# SERVICE BULLETIN

M-1209

July 5, 2007

## 2006 VRSCR EXHAUST SHIELD RECALL

Figure 1. Inner Exhaust Shield Installation on Rear Exhaust Pipe

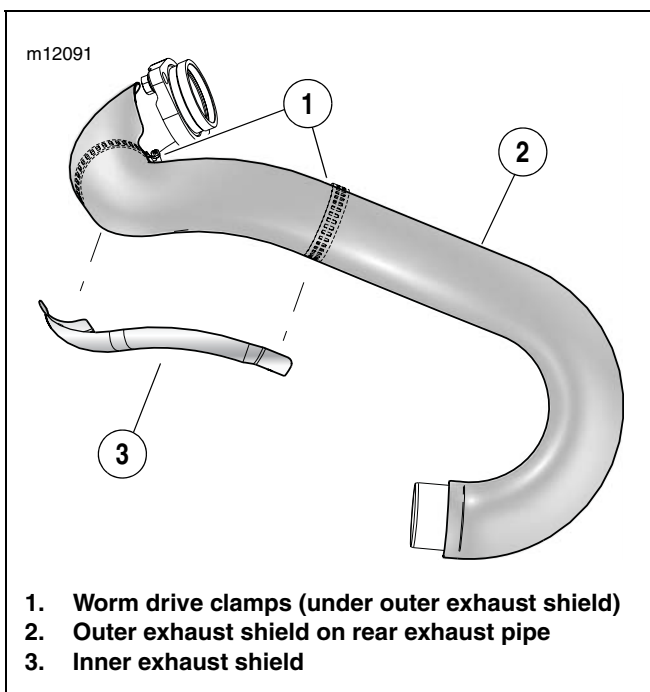
Harley-Davidson has determined that a condition affecting motor vehicle safety exists on 2006 VRSCR model vehicles. These vehicles have a condition whereby the pant leg of some riders can have direct contact with the exhaust pipe. This condition could cause the pant leg to char or burn, which could lead to the possibility of injury to the rider.

In the interest of motor vehicle safety and customer satisfaction, Harley-Davidson has elected to initiate a voluntary recall (0132). Recall 0132 consists of installing an additional exhaust shield on the inner side of the rear exhaust pipe, preventing the risk of the rider pant leg having direct contact with the exhaust pipe. You may sell **but not deliver** any affected motorcycles to your customers until the remedy is completed.

See Figure 1. If the vehicle is equipped with an original rear exhaust pipe (header) which does not have the inner exhaust shield installed, proceed to the installation instructions.

1. See Figure 1. Loosen both worm drive clamps (1) on the upper portion of the rear exhaust pipe.
2. Slide the **new** inner exhaust shield (3) against the exhaust pipe and into the clamps. The clamps should rest on the indented ends of the inner exhaust shield.
3. Tighten both clamps securely.
